External Fuse & Relay Center (EFRC) Cover Replacement

VOLVO

Years	Models
2025	VN

Introduction

External Fuse & Relay Center (EFRC) Cover Replacement

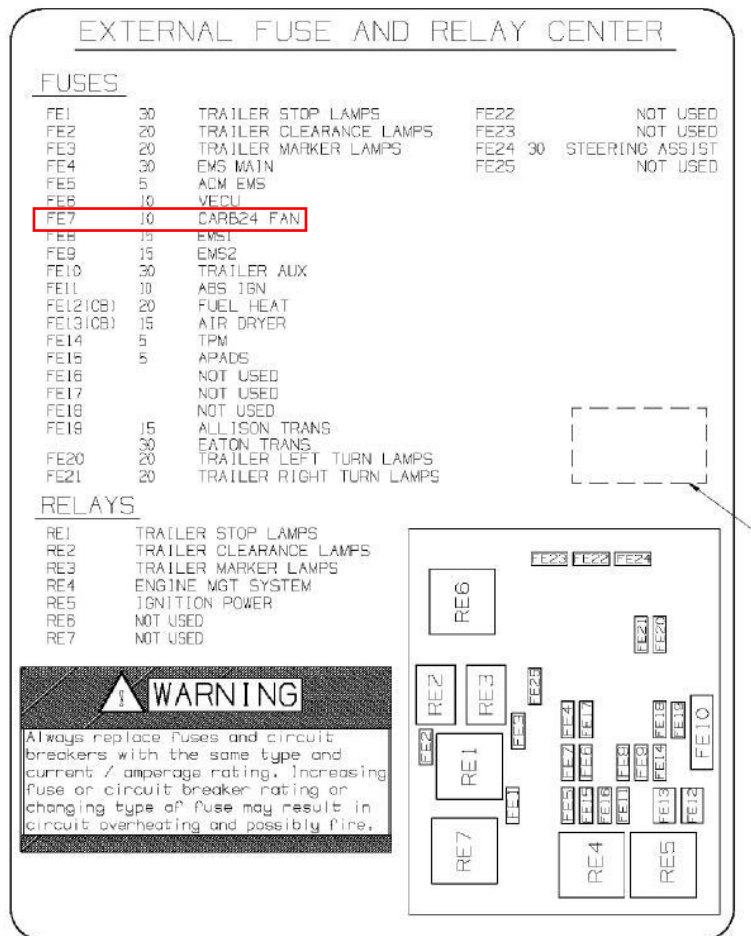
Volvo Trucks has determined that certain VN model trucks have a mislabeled Electronic Fuse & Relay Center (EFRC) Cover. The EFRC cover shows a 20A fuse for the FE7 location instead of the 10A fuse that is installed. Follow the instructions below to remove and replace the EFRC cover with a new, correctly labeled cover.

1. Secure the vehicle for service.
2. Locate and remove the incorrectly labeled EFRC cover that shows 20A in the FE7 position.
3. Verify 10A fuse is installed in the FE7 location.
4. Install new, correctly labeled EFRC cover that reflects the 10A fuse located in the FE7 position.
